工程指示 / 要求簡箋(E.I.)

工程名稱：觀塘裕民坊

工程項目：玻璃牆預留碼 (平台3/F)

Subject: Query for 3/F Glass Wall Bottom Fixing Detail

2 G.M.S. EMBED
PLAN & SECTION

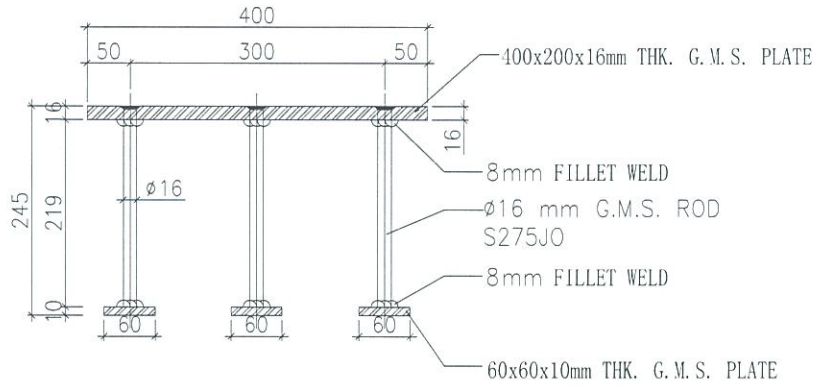
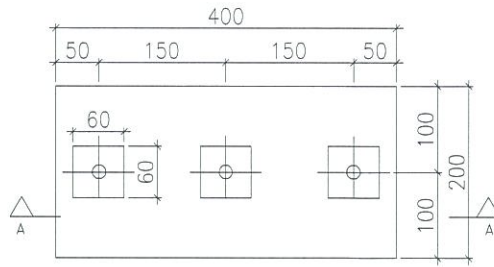
EM2 (EO1) x 185 nos

3 G.M.S. EMBED
PLAN & SECTION

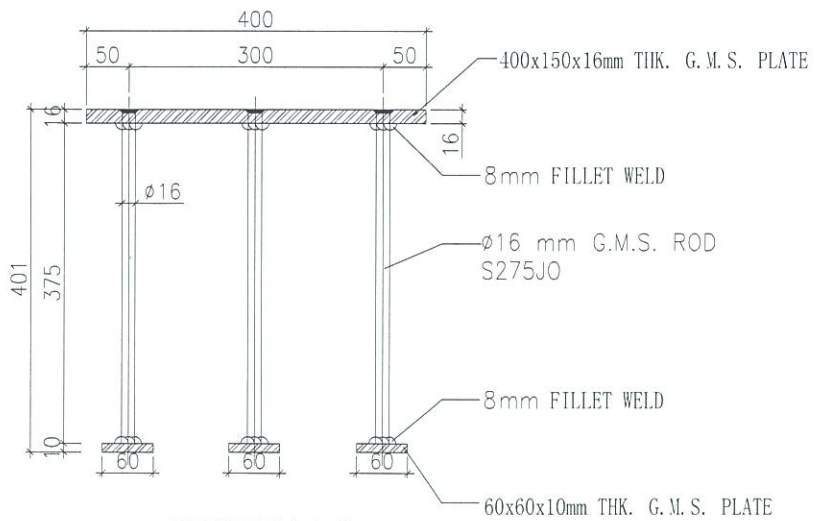
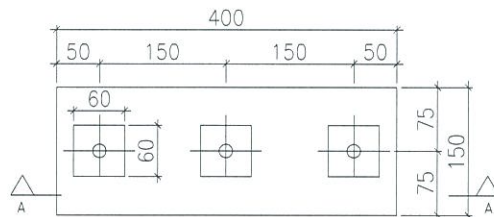
EM3 (EO2) x 43 nos

200mm R.C. CURB FOR GLASS WALL
AT 3/F

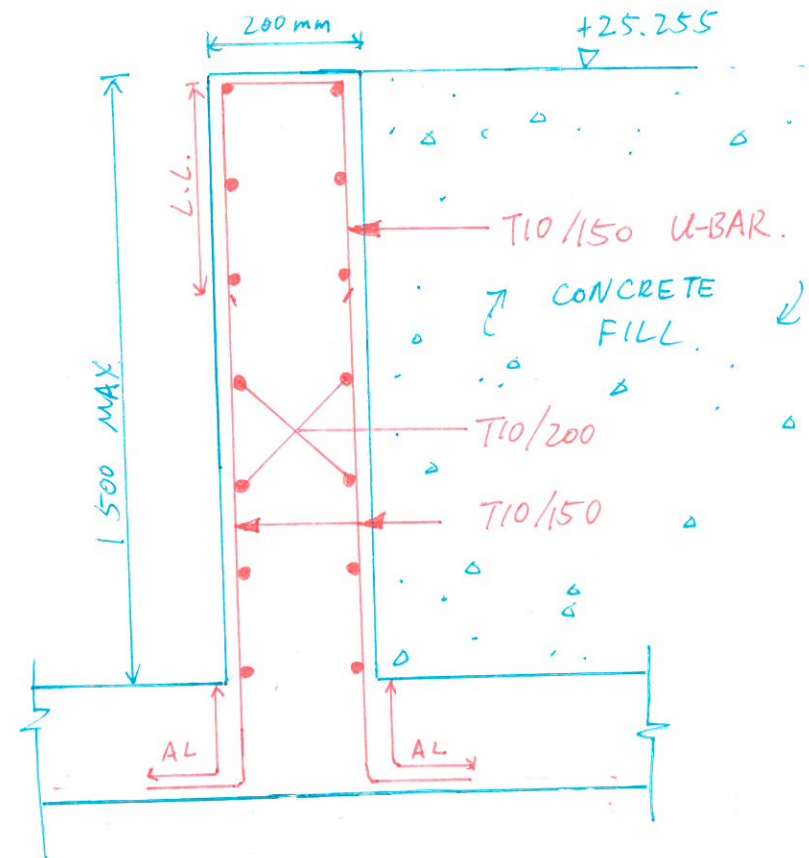
Query: As per discussed on 19/09/2018 Podium meeting, according to the latest 3/F framing plan, there are trench/ mass concrete fill under the 3/F glass wall and the depth is about 1355mm and 605mm difference between interior and exterior level.
Please advise whether the R.C curb to be constructed and provide the design intent for our study.

200mm CURB SHALL BE PROVIDED IN TRENCH/MASS CONCRETE FILL. PLEASE REFER TO SKETCH 2018/030-SSA-SK02
